Subject: Stinger Cylinder Extensions.

Unit/Part Affected: Screw on type extensions for stingers cylinders.

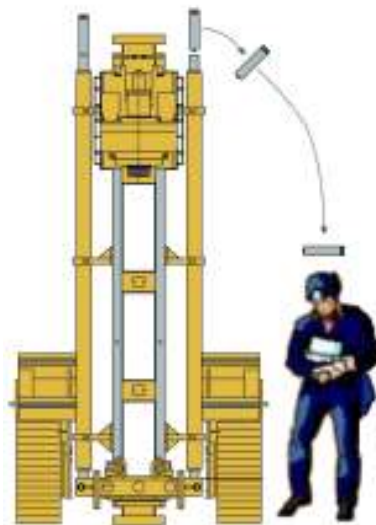
Purpose: To notify Cubex customers using the older style “Screw on” style, stinger cylinder extensions about a potential hazard. If the stinger cylinder extensions are not installed properly, they could vibrate loose and fall off causing serious injury.

1. When installing the extensions, the threads should be cleaned thoroughly and Blue Loctite applied. The extensions should then be tightened with a pipe wrench.
2. We recommend the use of the newer style “Pinned” extensions, which are designed to be safer and easier to use.
